Access Compliance Report

Public Rights-of-Way

(Curb Ramps)

Intersection ID: 29431	Main Street: CASTLE_TERRACE_CT	Cross Street: SHINY_MEADOW_LN	Location: NE
ADA ID: CE309C880493	Ramp Type: PerpDiag	Initial Pass/Fail: Fail	Overall Compliance: No
Severity Score: 21.25			
Codes/Mitigation Info/Possible Solution		Field Measurements/Component Compliance

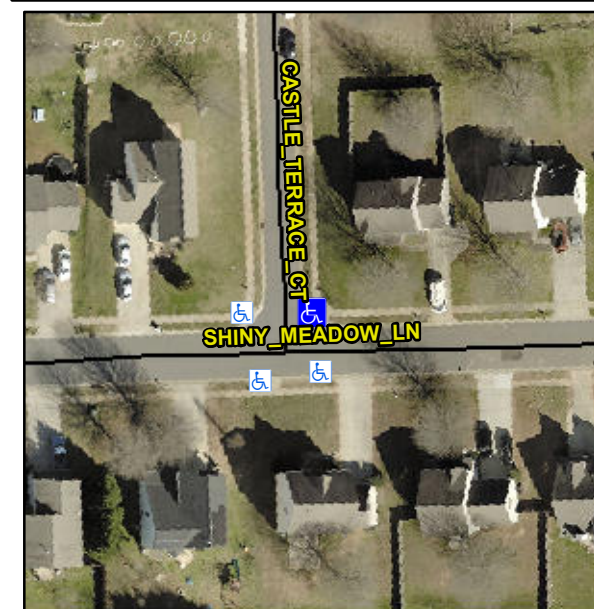
Not Found, R304.5.1, R304.5.3

Compliance	Description	Data	Compliance	Description	Data
N/A	Ramp Length (in)	47.5	Yes	Ramp Slope (%)	5.2
No	Ramp Width (in)	47.5	No	Ramp XSlope (%)	6.2
N/A	Flare Type LT	N/A	N/A	Flare Type RT	N/A
N/A	Flare Slope LT (%)	N/A	N/A	Flare Slope RT (%)	N/A
N/A	Flare Traversable LT?	N/A	N/A	Flare Traversable RT?	N/A
N/A	Landing Length (in)	N/A	N/A	DWS Provided?	N/A
N/A	Landing Width (in)	N/A	N/A	DWS Contrast?	N/A
N/A	Landing Slope (%)	N/A	N/A	DWS Length (in)	N/A
N/A	Landing X Slope (%)	N/A	N/A	DWS Full Width?	N/A
N/A	Landing Curb? (Y/N)	N/A	N/A	DWS Offset (in)	N/A
N/A	Shared Landing?	N/A			
N/A	Gutter Ponding?	N/A	N/A	Gutter Slope (%)	N/A
N/A	Gutter Lip Ht (in)	N/A	N/A	Gutter X Slope (%)	N/A
N/A	Painted X Walk1?	No	N/A	Painted X Walk2?	No
	X Walk 1 Direction	To W		X Walk 2 Direction	To S
N/A	X Walk 1 Width (in)	N/A	N/A	X Walk 2 Width (in)	N/A
	X Walk 1 Slope (%)	0.7		X Walk 2 Slope (%)	5.1
	X Walk 1 X Slope (%)	3.5		X Walk 2 X Slope (%)	1.7

N/A	Ramp inside XWalk1?	N/A	N/A	Ramp inside XWalk2?	N/A
	Road Slope (%)	2.5	N/A	Clear Space?	N/A
	Road X Slope (%)	2.0	N/A	Clear Space to XWalk (in)	N/A
N/A	Any Obstructions?	N/A	N/A	Storm Grate/Utility Hazard?	N/A
	Obstruction Type			Storm Grate/Utility Type	
		N/A			N/A
		Yes		Surface Condition? (G/P)	Good

Remove & Replace Curb Ramp With Two New Directional Ramps or Equivalent.
